Re: Unser Crossing- Building A
10550 Unser Blvd NW
Request for Certificate of Occupancy-30 Day Temp
Transportation Development Final Inspection
Architect's Stamp date 7-20-21 (A11D017B)
Certification dated 2-27-24

Re: Unser Crossing- Building B
10550 Unser Blvd NW
Request for Certificate of Occupancy-30 Day Temp
Transportation Development Final Inspection
Architect's Stamp date 7-20-21 (A11D017B)
Certification dated 2-27-24

UNSER CROSSING
ENLARGED SITE PLAN
10550 UNSER BLVD NW
ALBUQUERQUE, NM 87114
PROJECT #2063

SHEET NUMBER
AS-1.1

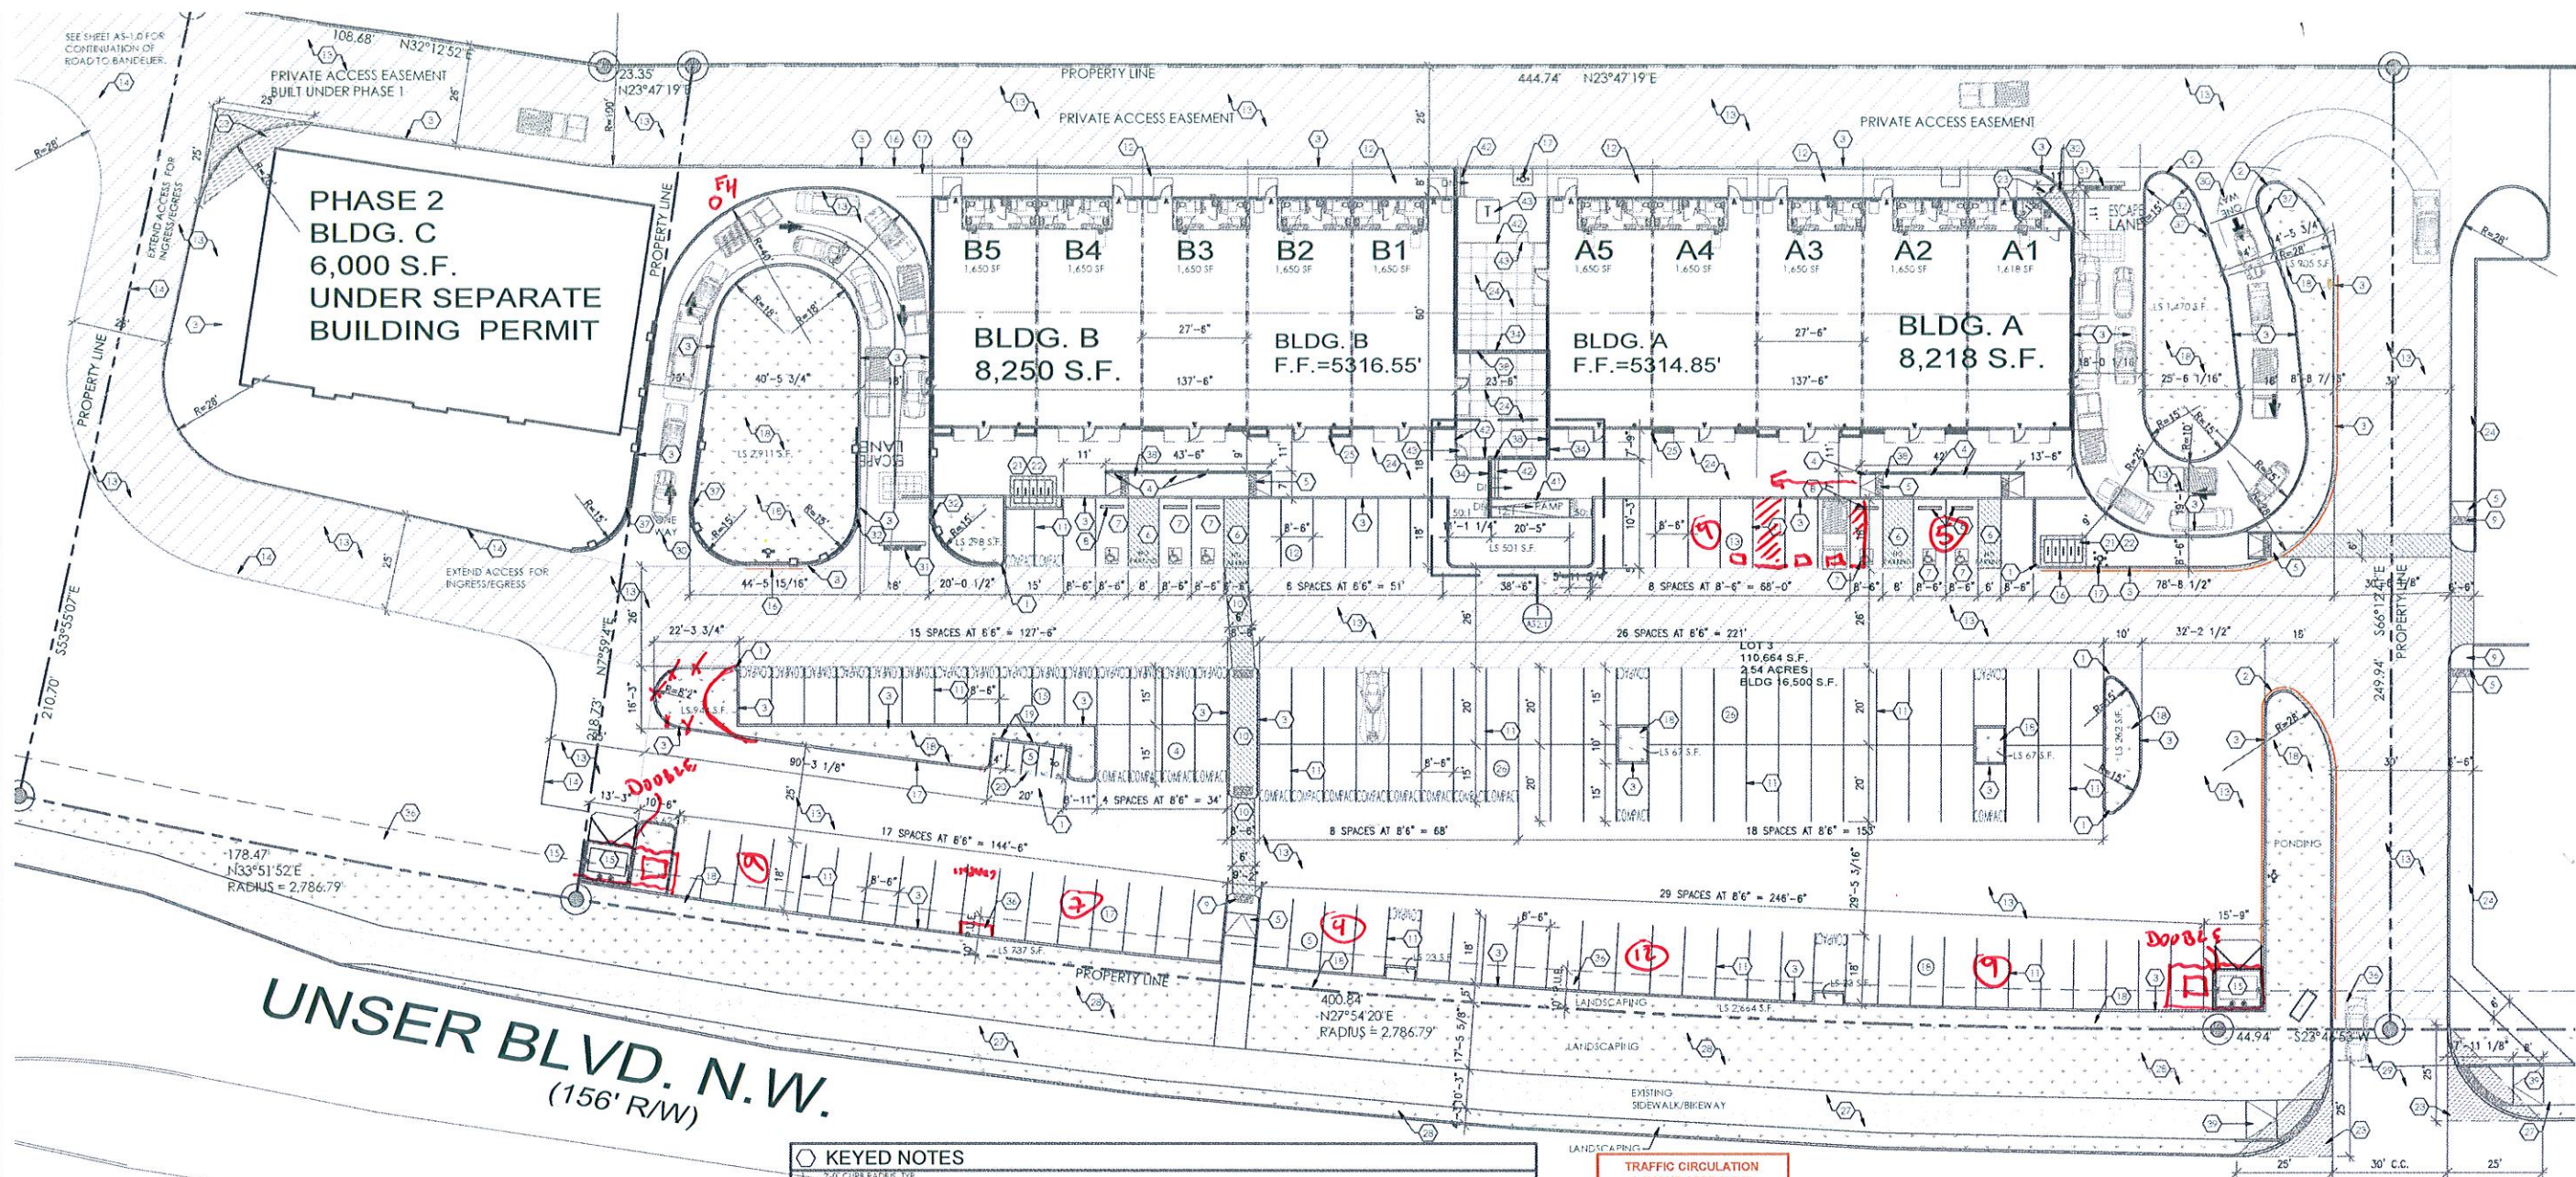
1. The installed size of each bike rack was not per plan: 14" wide.
2. The installed spacing between bike was not spaced per plan: 16" apart.

1. The installed size of each bike rack was not per plan: 14" wide.
2. The installed spacing between bike was not spaced per plan: 16" apart.
3. The drive-up was missing the "Do Not Enter" and One-Way" pavement markings.
4. The asphalt at the south edge of the site, east of the drive through, terminated into uneven dirt with piles of concrete and asphalt debris and the asphalt drive through the area labeled "Phase 2 Bldg C" was not constructed.
